SUPPLEMENTAL RESPONSE TO REQUEST FOR ADDITIONAL INFORMATION

APR1400 Design Certification

Docket No. 52-046

RAI No.: 129-8085
SRP Section: 03.08.01 –Concrete Containment
Application Section: 03.08.01
Date of RAI Issue: 08/05/2015

Figure 5-4 Containment Pressure for Loss of RHR (Mode 5)

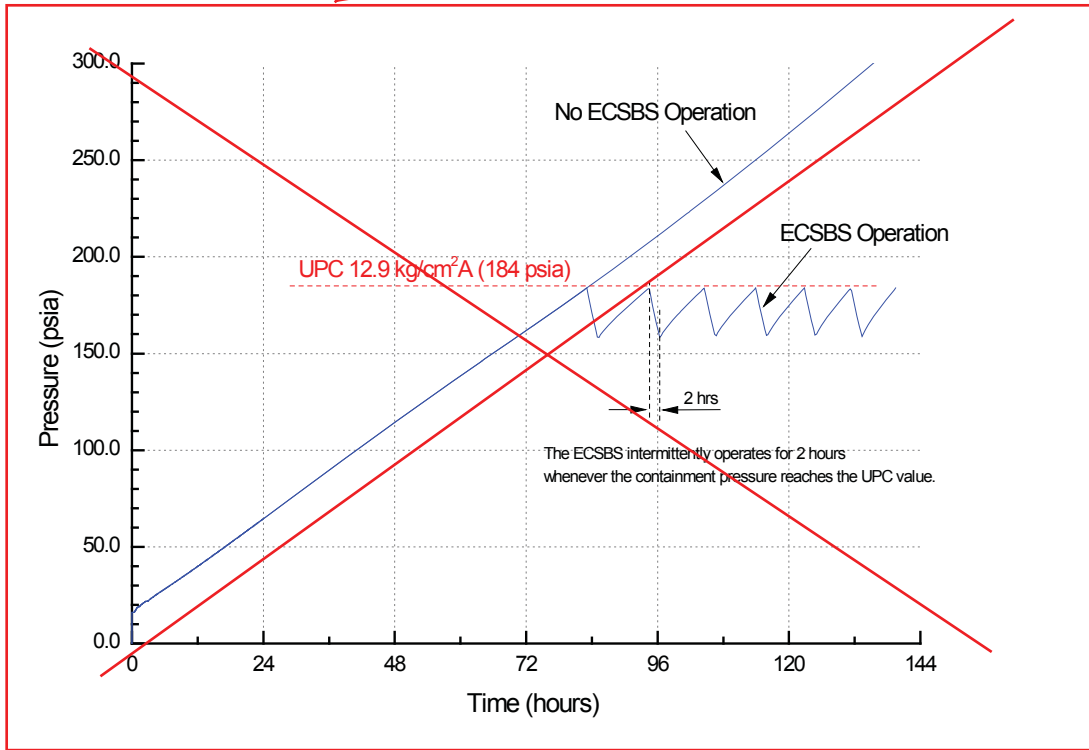
Technical Report “Evaluations and Design Enhancements to Incorporate Lessons Learned from Fukushima Dai-Ichi Nuclear Accident” (APR1400-E-P-NR-14005-P/NP, Rev. 0), Sections 5.1.2.3.3.3, 5.1.2.3.4.6, 5.1.2.5.3, and Figures 5-4 and 5-5 will be revised, as indicated in the attachment associated with this response.

GOTHIC analyses are performed for evaluation of the containment pressure and temperature responses following loss of RHR in mode 5. Figure 5-4 shows that the containment pressure reaches the UPC value in about 3.5 days without ECSBS operation, but with the intermittent operation of ECSBS, containment

Replace with A

Figure 5-5 Containment Temperature for Loss of RHR (Mode 5)

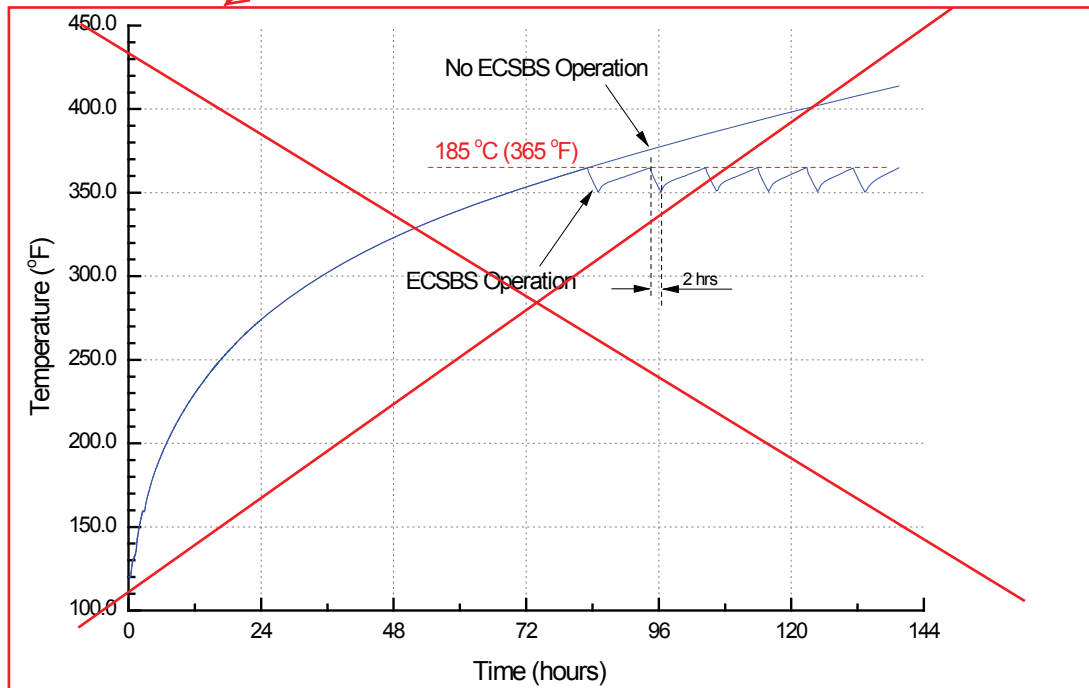
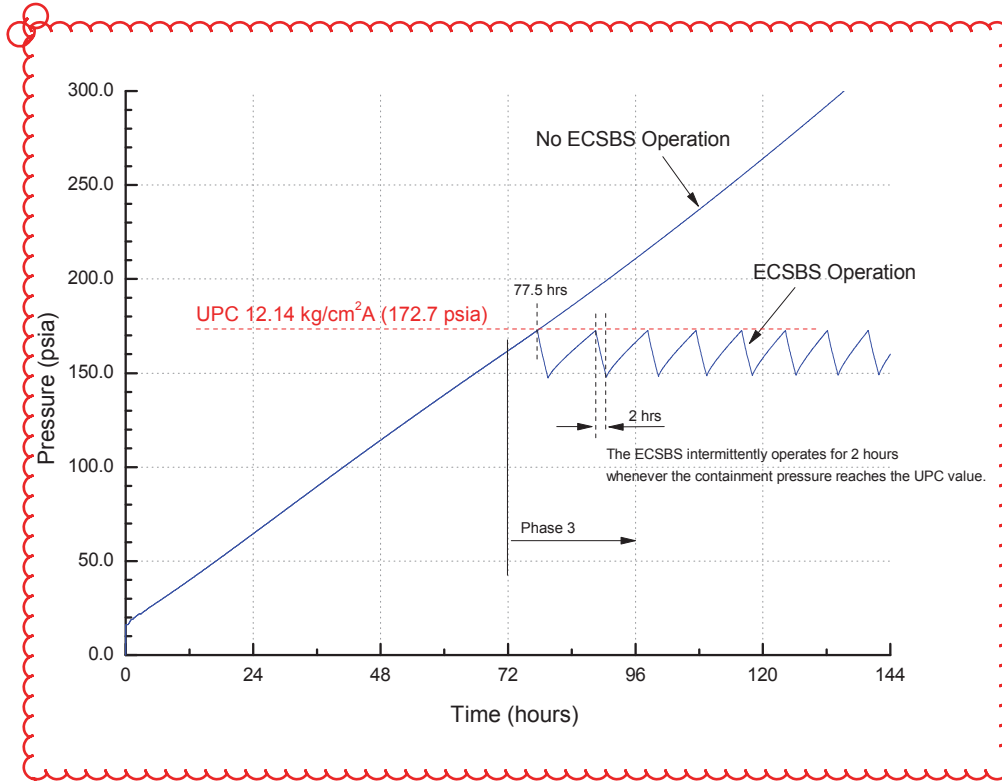
pressure can be maintained within the UPC limit. Figure 5-5 shows that the containment temperature is maintained well below ~~185 °C (365 °F)~~, which is less than the upper limit temperature of 196 °C (385 °F) for ensuring the operability of RCS sensors.

Replace with B
